**SUBDIVISION &
SIDEWALK WAIVER STAFF REPORT****Date: May 16, 2019****APPLICANT NAME**

Persons Development Subdivision

South side of Halls Mill Road, 425'± West of Rochelle Street.

Subdivision Approval to create one legal lot of record from an existing metes-and-bound parcel; and Sidewalk Waiver request to waive construction of a sidewalk along Halls Mill Road.

SITE PLAN

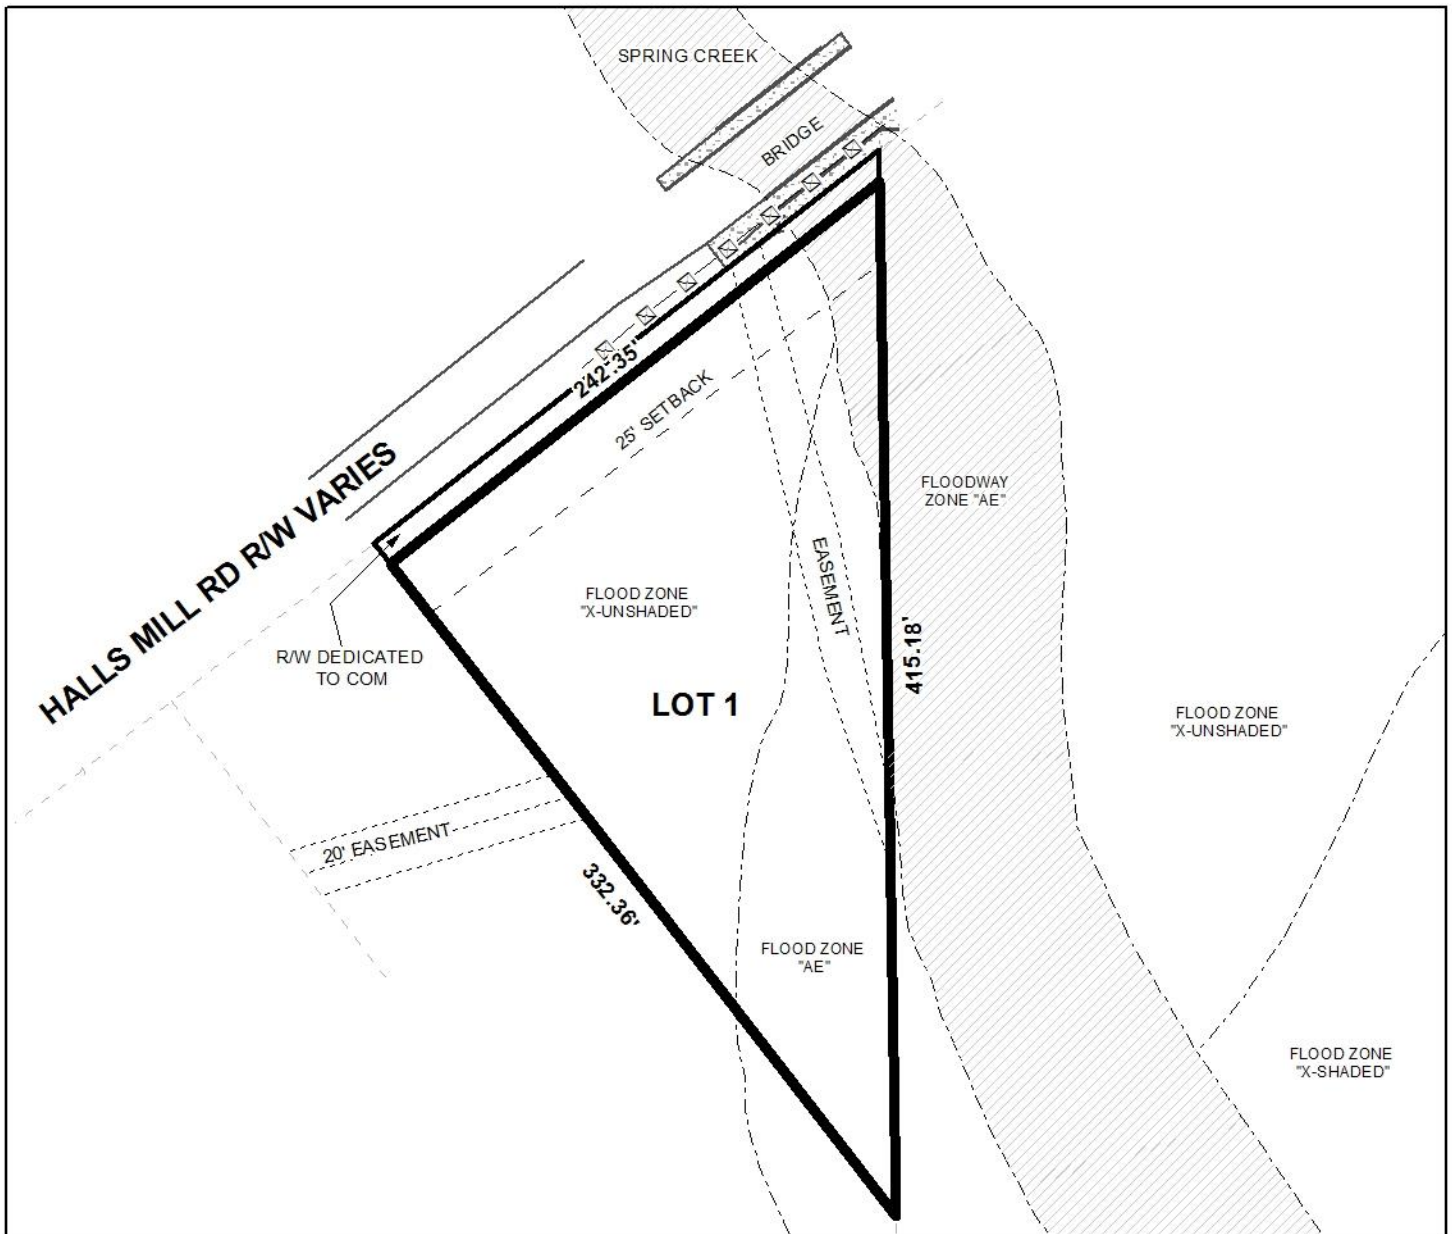
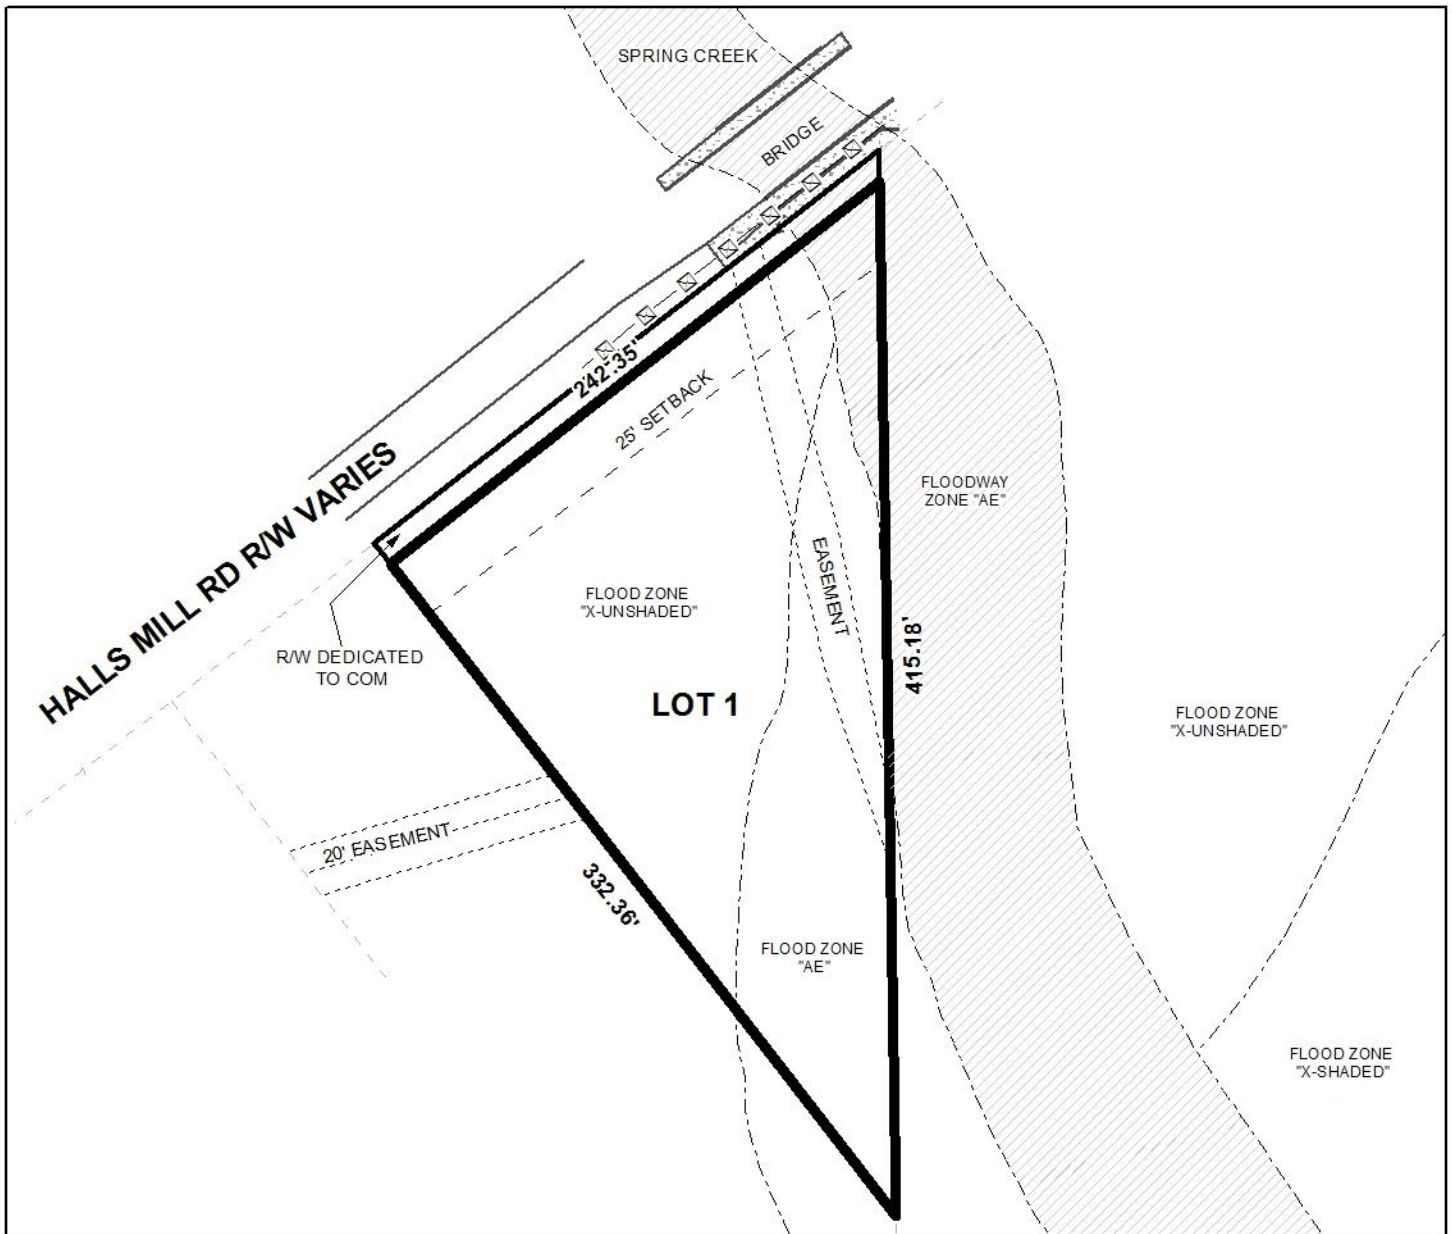
- B. Provide and label the reference monumentation for the corners labeled "NO CORNER SET" and "UNABLE TO SET" at the northeast corner of the propose lot.

- C. Revise the plat to label each lot with its size in acres and square feet, or the furnishing of a table on the Plat providing the same information.

- D. National Wetlands Inventory (NWI) mapping, as shown on City of Mobile GIS information, indicates that there is potential for wetlands within the property or properties shown on this plat. Show and label the delineated wetlands, or provide a note stating that the wetlands shown on this plat are scaled from the NWI data and have not been delineated.

- E. Provide a note that a 25' riparian buffer may be required, during development, along the edge of anything considered by ADEM to be a water of the state.

- F. Show and label all flood zones and boundary lines shown on the 2010 FEMA maps. Also indicate on the map by drawing or note that the proposed FEMA maps (2019) shows an increase in the X(unshaded) flood zone.

- G. Show and label the MFFE (Minimum Finished Floor Elevation) on each lot that contains an AE, V, or X (shaded) flood zone designation. Coordinate with City Engineering Dept. to provide the correct elevation.

The site has frontage along Halls Mill Road which is considered a minor arterial street and requires a 70' right-of-way. The preliminary plat indicates a variable right-of-way width along the front of the subject site with a 34.6' dimension given from the centerline of the asphalt pavement to the current right-of-way/front property line. A 10.0' dedication is indicated along the street frontage. As the asphalt may or may not be centered within the right-of-way, the current width from the actual centerline of the Halls Mill Road right-of-way to the current property line should be verified, and, if less than 35', dedication sufficient to provide 35' from the centerline should be required. The 25' minimum building setback line should be retained on the Final Plat as measured from any required frontage dedication.

Although stated in the application, the lot size is not given on the preliminary plat. Therefore, the plat should be revised to label the lot with its size in both square feet and acres, after any required frontage dedication, or a table should be furnished on the Final Plat providing the same information.

The plat indicates an existing drainage easement running through the site. Therefore, a note should be required on the Final Plat stating that no structure may be constructed or placed within this easement.

Specific to this site, City Engineering has determined that a sidewalk can be constructed West of the existing guardrail along the street frontage; therefore, the Sidewalk Waiver request should be denied for this portion of the frontage. City Engineering has determined that a portion of the bridge structure guardrail would have to be removed to construct a sidewalk in the right-of-way East of the existing guardrail; therefore, the Sidewalk Waiver should be approved for that portion of the frontage.

- 1) verification of the width from the actual centerline of the Halls Mill Road right-of-way to the current property line, and, if less than 35’, dedication sufficient to provide 35’ from the centerline is required;

- 2) retention of the 25’ minimum building setback line as measured from any required dedication;
- 3) revision of the plat to label the lot with its size in both square feet and acres, adjusted for any required dedication, or the furnishing of a table on the Final Plat providing the same information;

- 4) placement of a note on the Final Plat stating that no structure may be constructed or placed within any easement;
- 5) compliance with the Engineering comments: *[FINAL PLAT COMMENTS (should be addressed prior to submitting the FINAL PLAT for review and/or signature by the City Engineer): A. Provide all of the required information on the SUBDIVISION PLAT (i.e. signature blocks, signatures, certification statements, written legal description, required notes, legend, scale, bearings and distances) that is required by the current Alabama State Board of Licensure for Professional Engineers and Land Surveyors. B. Provide and label the reference monumentation for the corners labeled “NO CORNER SET” and “UNABLE TO SET” at the northeast corner of the propose lot. C. Revise the plat to*
